25 May 2021 Job number 078/025

## **Waterloo Metro Quarter Development**

WMQD Northern Precinct 1 | City of Sydney Response to RtS

5 Martin Place Sydney
 Barangaroo Towers 1,2 & 3 Sydney
 Quay Quarter Tower Sydney

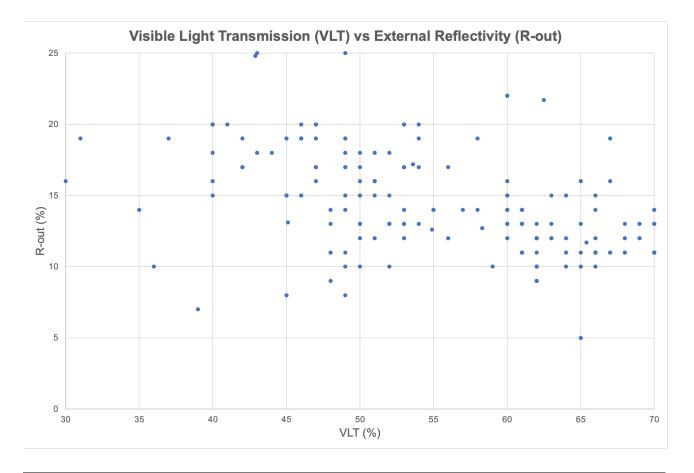
"7. External sun shading – City staff refer to the Amended Design Integrity Report at page 20, which says "The panel notes that whilst thermal comfort levels may be achieved with the reduced facade projection, it is disappointing to rely wholly on glazing specifications, which may result in darker and more reflective glass than would have been the case if a brise soleil with greater depth had been pursued".

The proposed tower vision glass performance for the WMQ Northern Precinct (Building 1) has transparency and solar control consistent with many buildings similar to its type, including but not limited to:

Architectural, ESD and glass selection exercises have strived to maintain visual clarity and reflectivity on-par with these reference projects, despite the additional challenges that have swept the industry following the changes of NCC 2019 Section J. We note that glass performance parameters have been tuned to maximise transparency / visible light transmission (VLT) while delivering solar control (SHGC) as required for performance of the envelope. This has led to specification of an intended glass product targeting:

- VLT 50%;
- SHGC = 0.23;
- External reflectivity < 20%</li>
